Review of DGS Report No. NAR-005/2: Mine Subsidence Assessment for the Narrabri Underground Mine Stage 3 Extension Project

John Matheson BE (Hon), CPEng, MIEAust, NPER

25 February 2022

Figure 2 Approximate extent of longwall panels LW203-LW209 shown as a red-coloured rectangular shape superimposed on the Hoskissons Seam, Figure 3c reproduced courtesy of DgS.

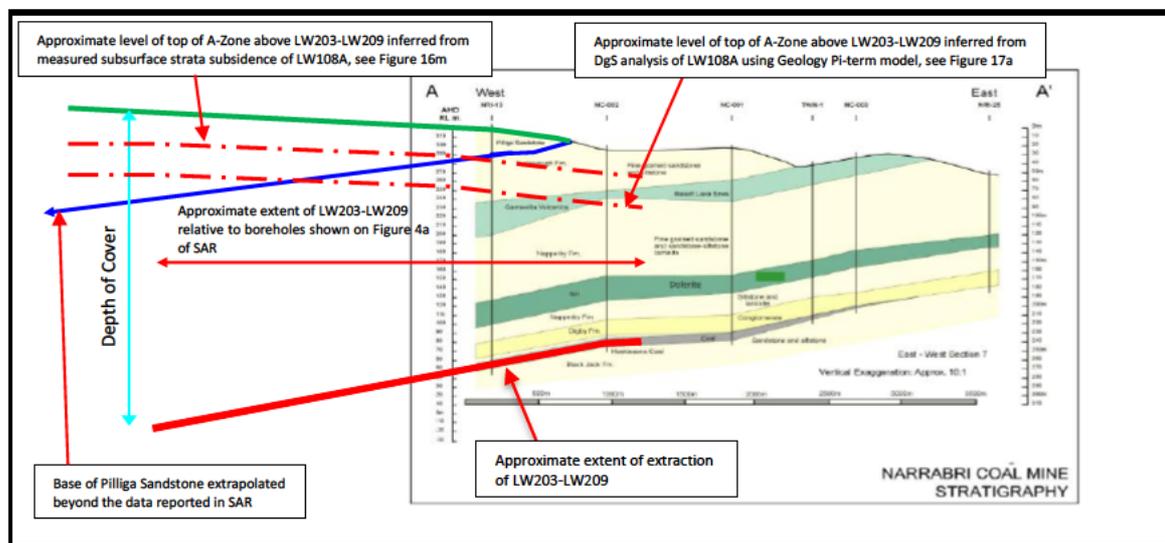
The subsurface geology is described in the SAR, with a key figure reproduced in this report as **Figure 2**. The SAR variously notes that the rock strata dips to the west or southwest at up to 3°-5° or up to 52mm/m-87mm/m (that is a dip of 52-87mm for every metre of distance). Borehole NRI-13 is located approximately 1,020m from the tailgate or eastern edge of longwall panel LW203 (to the east) and approximately 2,275m from the maingate or western edge of longwall panel LW209 (to the west). The dip of the Pilliga Sandstone is assumed to continue in a westerly direction beyond borehole NRI-13, as shown by me in **Figure 2**. The approximate location of longwall panels LW203-LW209 are shown in **Figure 2** by a red-coloured rectangular shape superimposed on the Hoskissons Seam.

The Pilliga Sandstone and to a lesser degree, the overlying Rolling Downs Group, contain aquifers, which drain towards the Coonamble Embayment of the Great Artesian Basin (Herr et al). The interface between the Pilliga Sandstone and the underlying Purlawaugh Formation has been shown extended and dipping further to the west of borehole NRI-13, see **Figure 2**. This provides a clearer understanding of the increasing thickness and depth of the Pilliga Sandstone above LW206-LW209 than has been provided by **Figure 3** of the SAR (reproduced here as annotated in **Figure 2**), which is consistent with the subsurface geology shown in **Figure 1**.

The strata underlying the Pilliga Sandstone, being the Purlawaugh Formation and much of the underlying strata down to the Hoskisson Seam are regarded as Aquitards, except for the Napperby Formation, the Ulinda Sandstone (Digby Formation) and the Clare Sandstone (Black Jack Group overlying the Hoskissons Coal Seam), which are potential or poor aquifers. These additional potential or poor aquifers lie within the A-Zone and could be impacted by connective cracking.

Figure 3 Extract copy of Figure 15a of the SAR

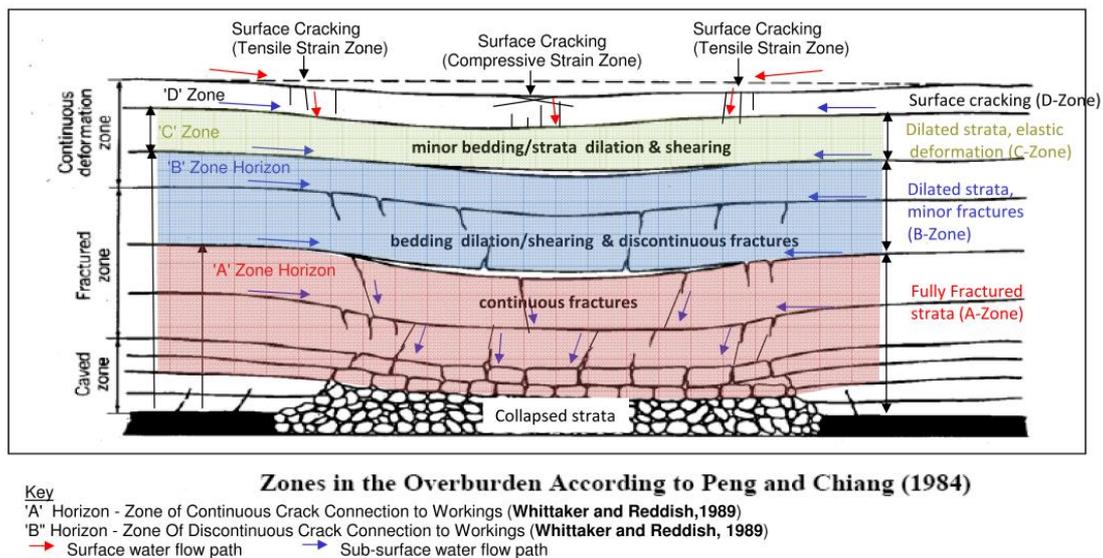
Based on the subsidence mechanisms described by Peng & Chiang and presented in **Figure 15a** of the SAR, (see **Figure 3** of this report), continuous fractures could develop in the fully fractured A-Zone. The SAR reports that the height of the A-Zone could range up to between 0.8- to 0.9-times the depth of cover at the 95% CL, see extract copies of **Figures 16m and 17a** of the SAR, in **Figure 4**. This means that the probability that the top of the A-Zone could be higher than predicted (i.e., between 0.8- to 0.9-times the depth of cover), is low.

I have superimposed the height of the A-Zone estimated from **Figures 16m and 17a** reported in the SAR, on **Figure 2** of this report as a pair of nearly parallel red dashed curved lines on the extract of the Narrabri Coal Mine Stratigraphy. Noting that all the data is not available to use in this review, it is possible, if not likely, that A-Zone connective cracking could extend up into the Pilliga Sandstone. The uppermost red dashed line ( $A/H=0.9$ )<sup>3</sup> derived from **Figure 16m** of the SAR and shown in **Figure 2** above, does not appear to encroach within 20-metres of the ground surface and connective cracking, therefore, could extend up into the Pilliga Sandstone above LW205-LW209 and impact an area estimated to measure approximately 10.5km x 1.8km depending on the limit of the outcrop. The SAR notes on page **ES-4** that A-Zone connective cracking is considered **unlikely** to encroach within 20-metres of the surface.

Figure 4 The A-Zone horizon above LW108A derived from subsurface strata subsidence measurements above LW108A (indicated by the red arrow) in the left frame and as predicted by the Geology Pi-term model upper 95% confidence interval in the right frame.

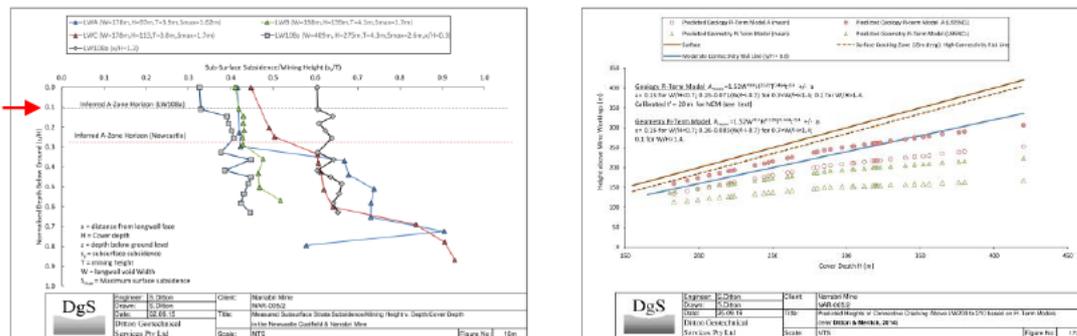
The SAR states that B-Zone sub-surface fracturing in the constrained zone, which contains aquitards like the Purlawaugh Formation immediately below the Pilliga Sandstone, is likely to interact with surface cracks (D-Zones) in the Pilliga Sandstone, where cover depths are < 300 m above the 306 m wide panels and < 375 m above the wider longwalls, which includes LW203-LW209. The SAR further states that based on a depth of surface cracking of 15-metres and possible connectivity between A- and B-Zones, that there is up to a 25% probability that connective cracking could impact the surface. The SAR does not refer to the potential impact of the A-Zone cracking on the Napperby Formation, Ulinda or Clare Sandstone strata.

Figure 5 Description of far-field movement described in the SAR

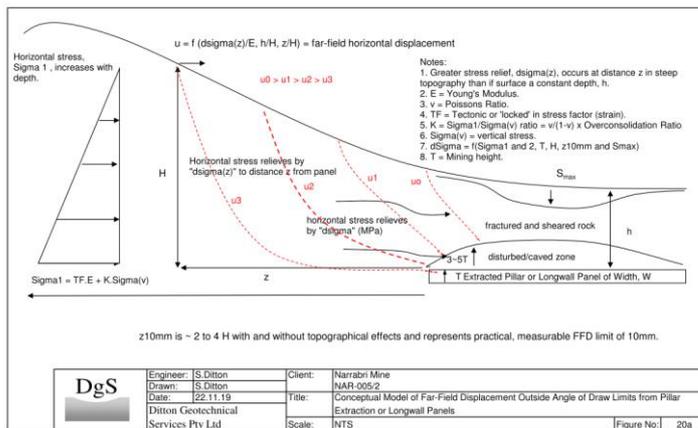
I am currently involved with monitoring ten (10) structures located in the Southern Coalfields at offset distances from the nearest longwall panel of between 0.9km-1.2km. Potential areas of impact include horizontal valley closure displacement, vertical upsidence displacement and sideways racking<sup>9</sup> displacement of structures, and the potential for far field movement to concentrate at one location and cause significant opening of pre-existing fault zones, rock joints or cracks, which could impact overlying structure, whether geological or built.

According to **Figure 20a** of the SAR, inwards far-field movement of up to 10mm could occur at up to twice the depth of cover when allowing for topographical effects and four-times the depth of cover without topographical effects, see **Figure 6**. The inwards horizontal ground movement should progressively increase towards the 20mm subsidence contour or where the angle of draw intersects with the ground surface increasing horizontal stress.

The sloping rock faces and minor cliff lines beyond the southern end of LW205-LW207 are located within 0.3km of the end of the longwall panels LW205-LW207, which is much closer to the proposed longwall panels than the structures that are monitored in the southern coalfields (0.9km-1.1km).

Figure 6 Lidar survey showing steep slopes and cliffs

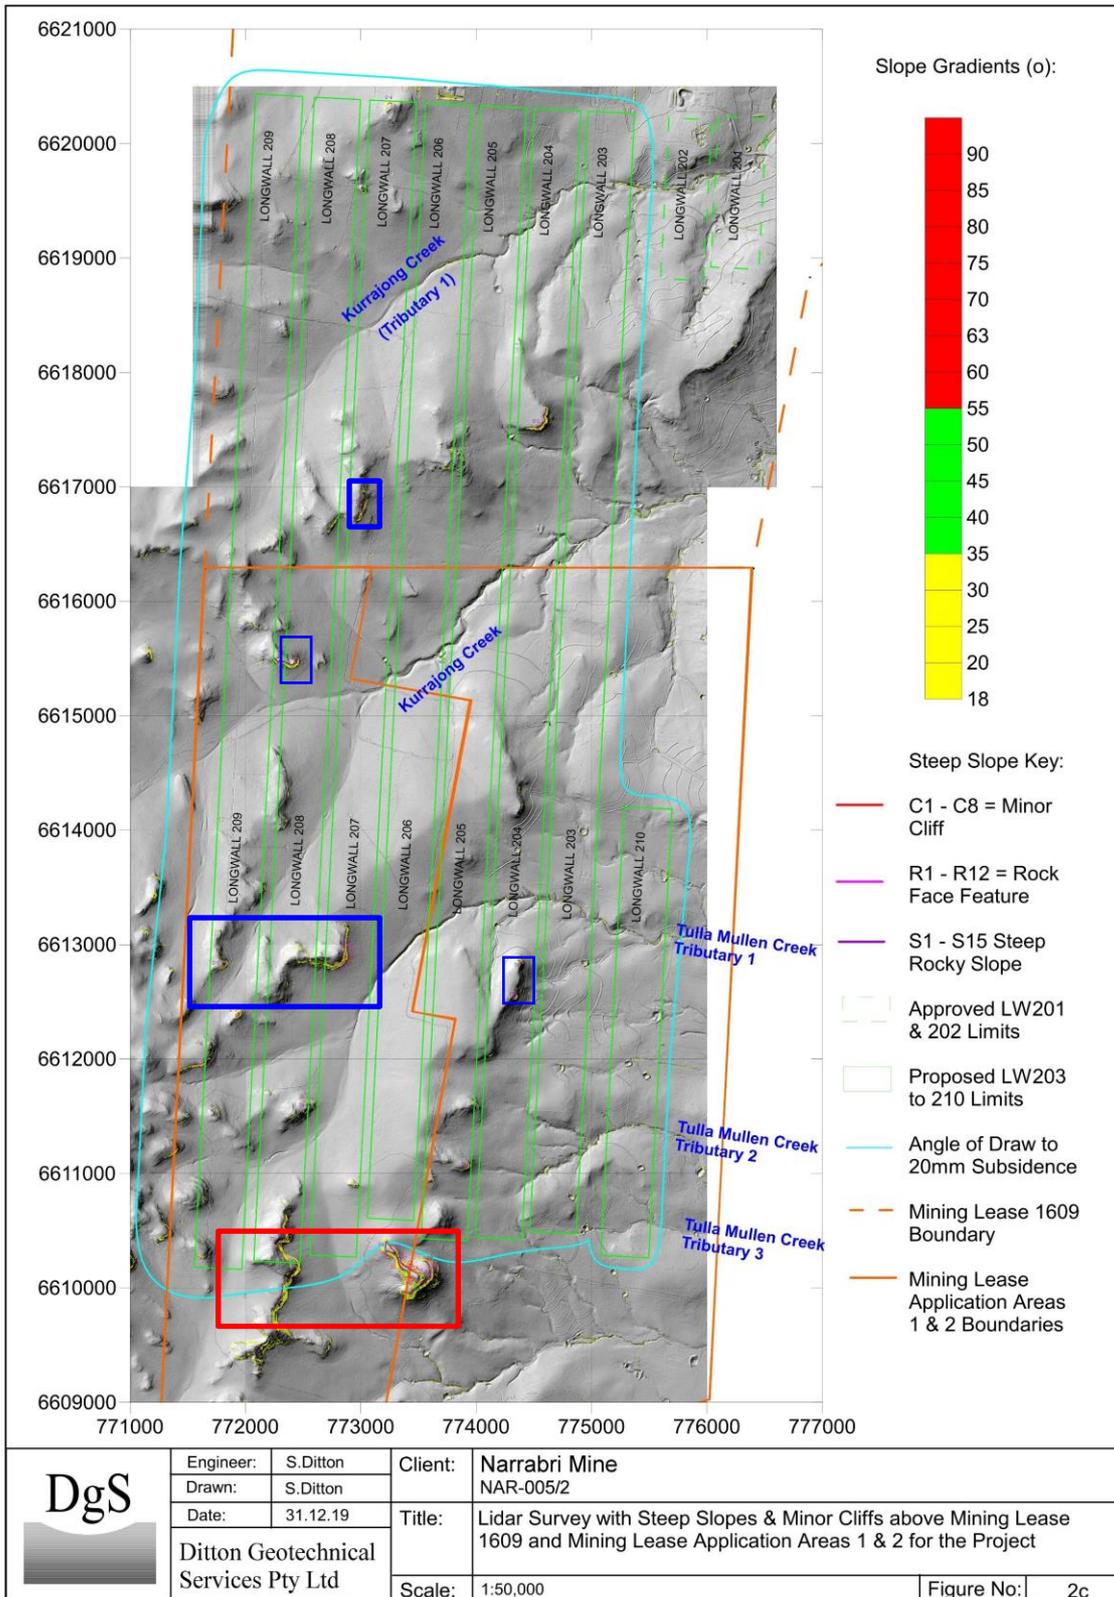
The SAR notes that the exposed strata on the minor cliff faces and steep rocky slopes consist of blocky, medium bedded Quartzitic Sandstone beds of low to medium strength. Furthermore, small to large sandstone boulders and weathered sandstone exposures form steep, rocky talus slopes below the minor cliff faces.

The SAR notes on page 42 that undermining ridges can also result in surface cracks migrating upslope and outside the limits of extraction for significant distances due to rigid block rotations. Depending on topography and rock jointing cracks can migrate outside the limits of longwall extraction in Newcastle for distances up to 0.2 times the depth of cover.

If far field movement concentrates at one location around the steeply sloping rock faces and small cliffs, and the type of cracking that occurred in Newcastle, re-occurs in Narrabri, it is possible for rock joints between the blocks that comprise the minor cliffs to open and propagate in depth and length as described above, which could impact rock face stability.

Figure 7 Theoretical stress distribution and hydrogeological model above and adjacent to longwall panel extraction after Forster and Enever (1992)

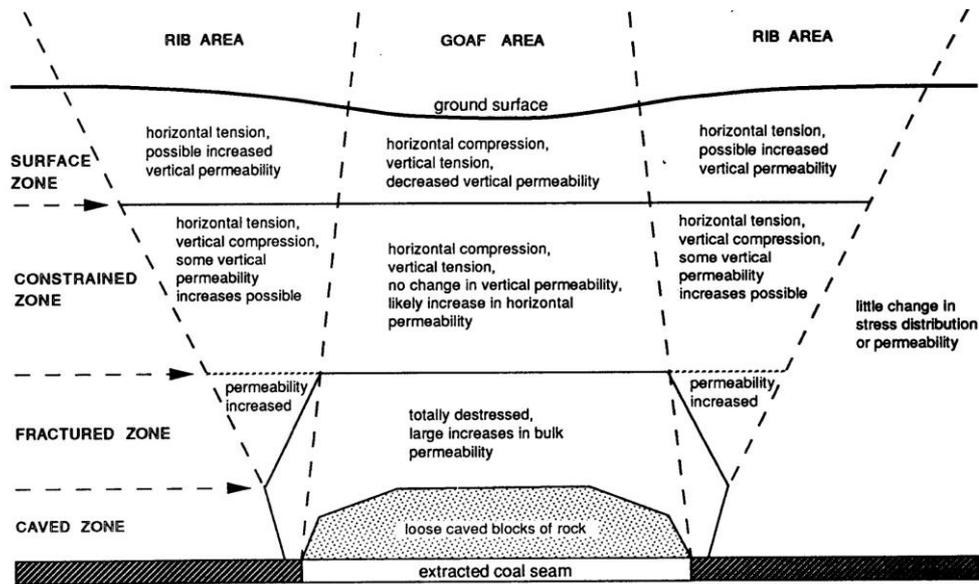
The theoretical stress distribution and hydrogeologic model proposed by Forster and Enever indicates that increased vertical permeability could be expected in the constrained zone of the rib area, which is located generally above the sides and ends of the longwall panel, see **Figure 7**. A decrease in vertical permeability is expected in the surface zone whilst horizontal and vertical permeability are expected to increase or not change, respectively, in the constrained zone if the A-zone does not extend to within 20metres of the ground surface. The statement on ES-5 of the SAR that “Discontinuous fracturing would normally be expected to occur above the proposed mining area, causing an increase in rock mass storage capacity and horizontal permeability, without direct hydraulic connection to the workings. Groundwater levels would be lowered in the medium to long terms as a consequence of these impacts”, is reasonable, if the discontinuous fracturing generally occurs in the Purlawaugh Formation, a known Aquitard.
